Re: Request For a Hearing on the Solid Waste Facility Permit Application for the  
Proposed Gregory Canyon Landfill

## STATEMENT OF THE ISSUES

FIGURE 30B

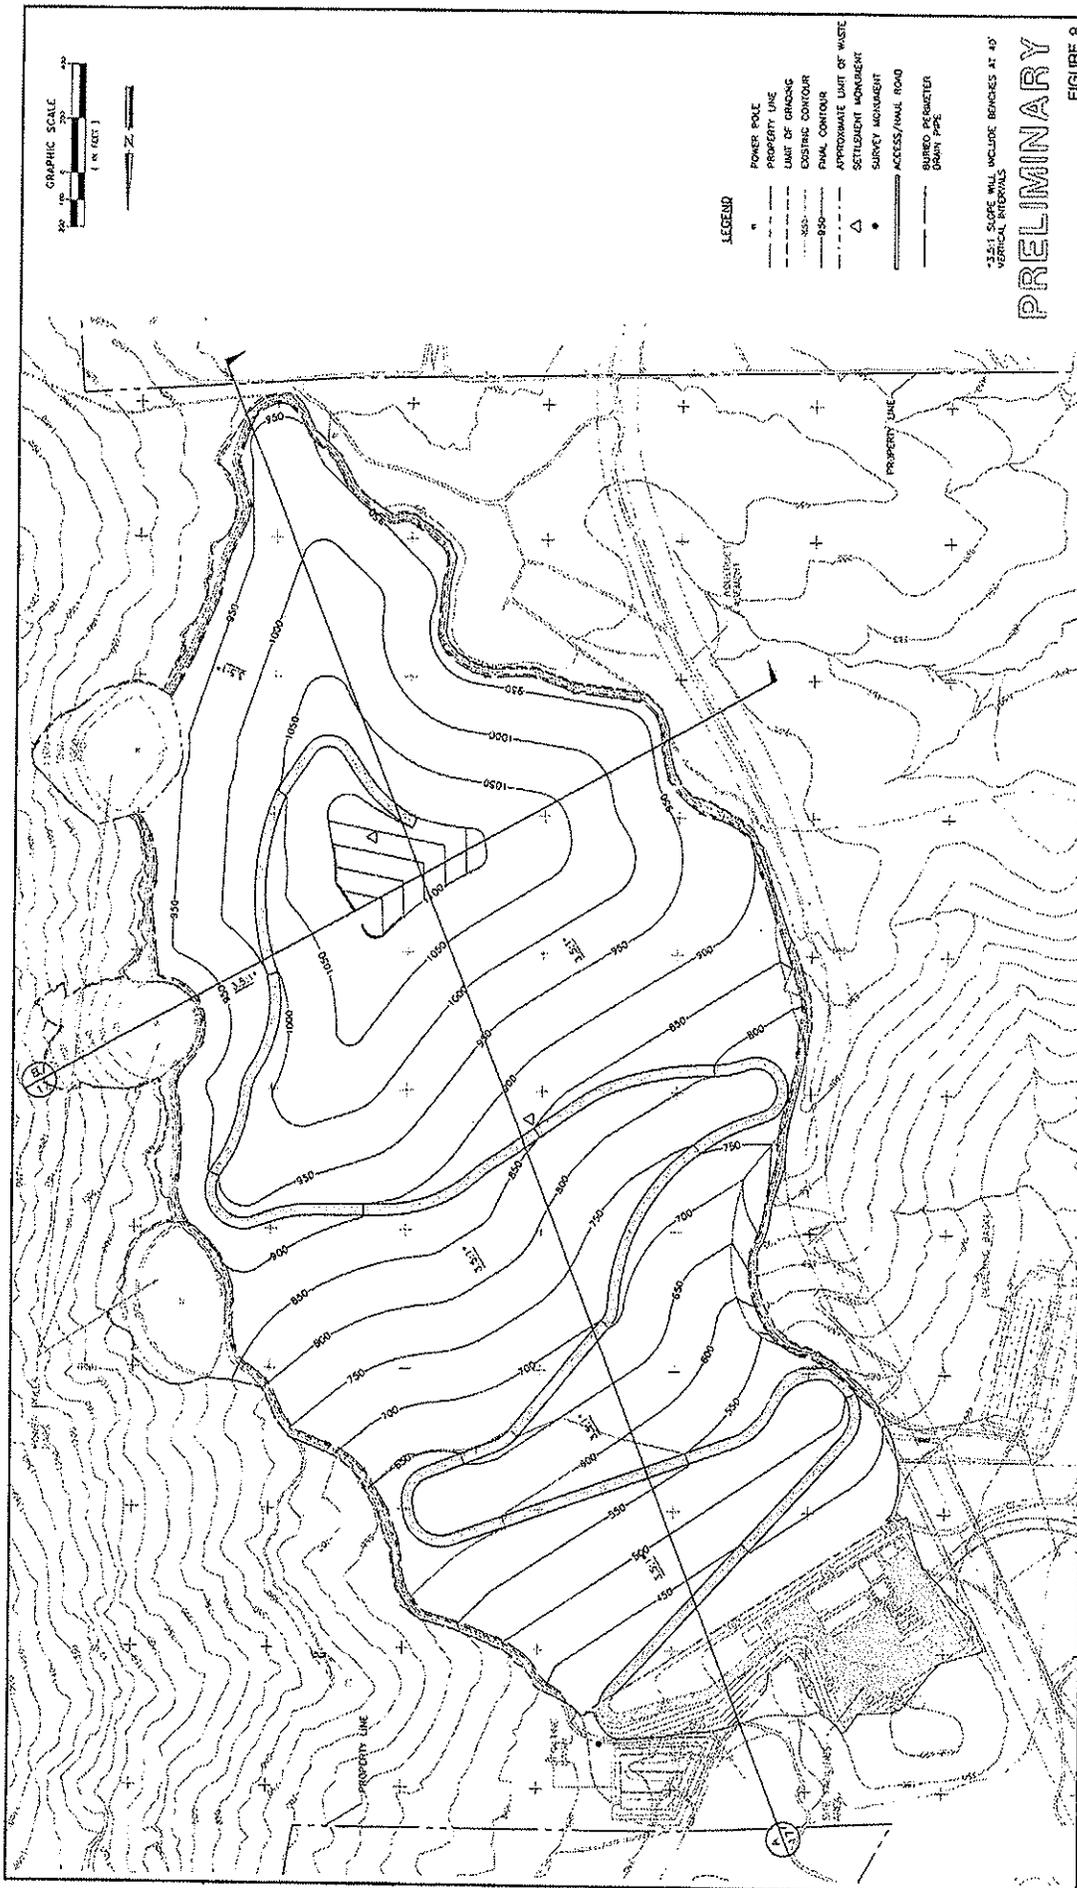
The JTD fails to mention that the eastern desilting basin, infiltration area and potentially part of the facilities area, including the proposed flare station, are within the 100-year floodplain shown on Figure 30B attached as Exhibit K. That figure shows the where the floodplain area is located and Figure 9 shows that same area on the left along the property line. Because no analysis of the impacts of this construction on the floodplain has been conducted and no approvals from FEMA have been obtained, the SWFPA is not complete and correct.
